Access Compliance Report

Public Rights-of-Way

(Curb Ramps)

Intersection ID: 10033765	Main Street: OXFORD COMMONS DR	Cross Street: N/A	Location:	N
ADA ID: 7E1FB2CA89A4	Ramp Type: Perp	Initial Pass/Fail: Fail	Overall Compliance: No	Severity Score: 10
Codes/Mitigation Info/Possible Solution		Field Measurements/Component Compliance

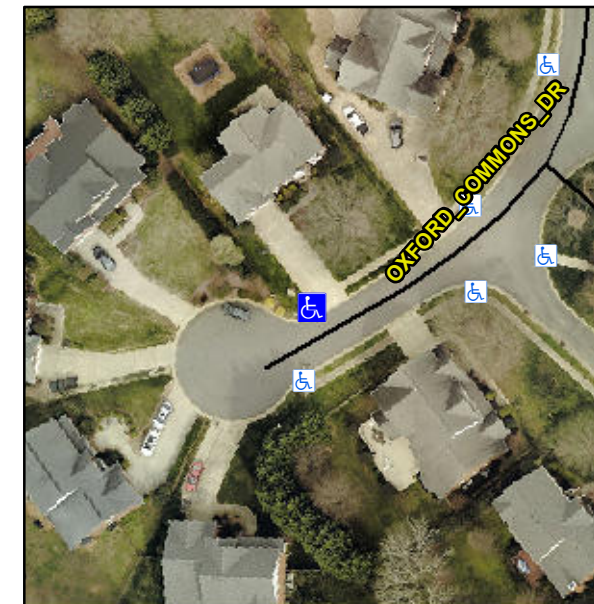
Not Found, R304.5.1, R304.5.3

Compliance	Description	Data	Compliance	Description	Data
N/A	Ramp Length (in)	46.0	Yes	Ramp Slope (%)	6.2
No	Ramp Width (in)	46.0	No	Ramp XSlope (%)	2.4
N/A	Flare Type LT	N/A	N/A	Flare Type RT	N/A
N/A	Flare Slope LT (%)	N/A	N/A	Flare Slope RT (%)	N/A
N/A	Flare Traversable LT?	N/A	N/A	Flare Traversable RT?	N/A
N/A	Landing Length (in)	N/A	N/A	DWS Provided?	N/A
N/A	Landing Width (in)	N/A	N/A	DWS Contrast?	N/A
N/A	Landing Slope (%)	N/A	N/A	DWS Length (in)	N/A
N/A	Landing X Slope (%)	N/A	N/A	DWS Full Width?	N/A
N/A	Landing Curb? (Y/N)	N/A	N/A	DWS Offset (in)	N/A
N/A	Shared Landing?	N/A			
N/A	Gutter Ponding?	N/A	N/A	Gutter Slope (%)	N/A
N/A	Gutter Lip Ht (in)	N/A	N/A	Gutter X Slope (%)	N/A
N/A	Painted X Walk1?	No	N/A	Painted X Walk2?	N/A
	X Walk 1 Direction	To S		X Walk 2 Direction	N/A
N/A	X Walk 1 Width (in)	N/A	N/A	X Walk 2 Width (in)	N/A
	X Walk 1 Slope (%)	5.0		X Walk 2 Slope (%)	N/A
	X Walk 1 X Slope (%)	0.3		X Walk 2 X Slope (%)	N/A

Remove & Replace Entire Ramp.
